SIDE - TONE MODIFICATION

(Circuit Board 1092-2, SPA-400 Panel Mount, S/N 60500-60974)

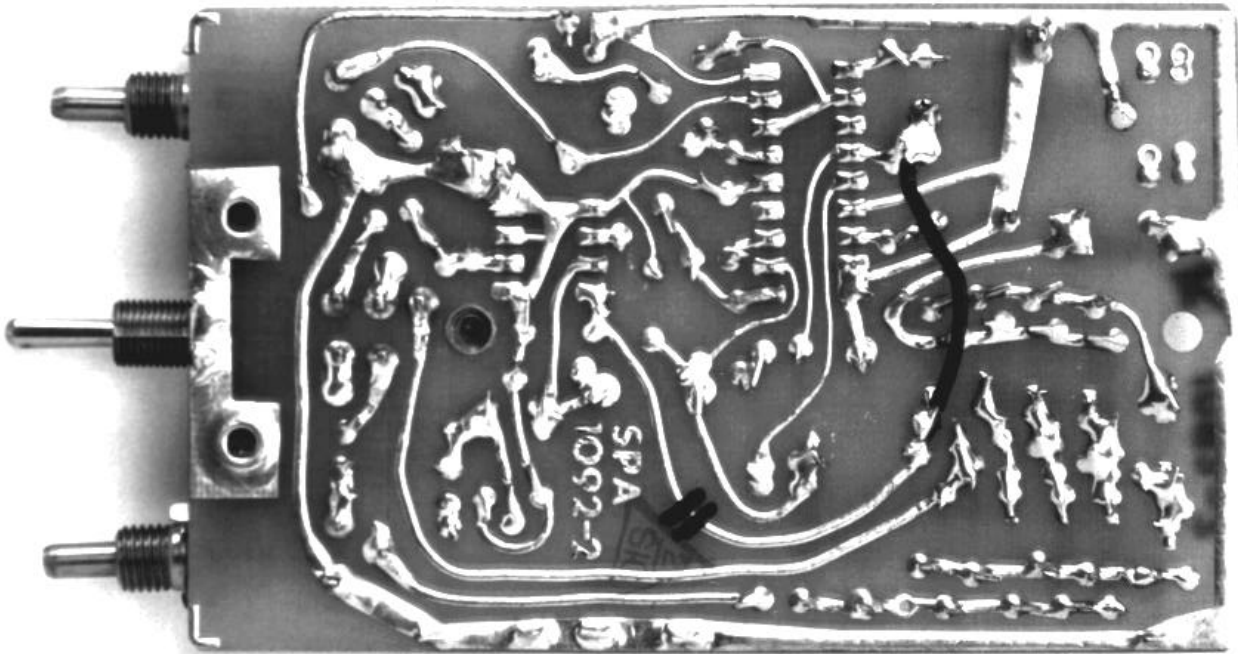
Most aircraft radios have side-tones; however, it has been noted that some of the Cessna 300 and 400 series, as well as some other radios, do not. Without side-tone, you will not hear yourself or your co-pilot transmit to ATC. If the Transcom is used for instruction and/or you wish to hear the transmissions, a simple modification can be performed within the unit to simulate side-tone. This is accomplished by separating the etch where indicated and installing a jumper as illustrated.

The SPA-400 required partial disassembly to accomplish the side-tone modification. To disassemble unit, carefully remove the screws securing the cover; back each screw out evenly to prevent the cover from bending.
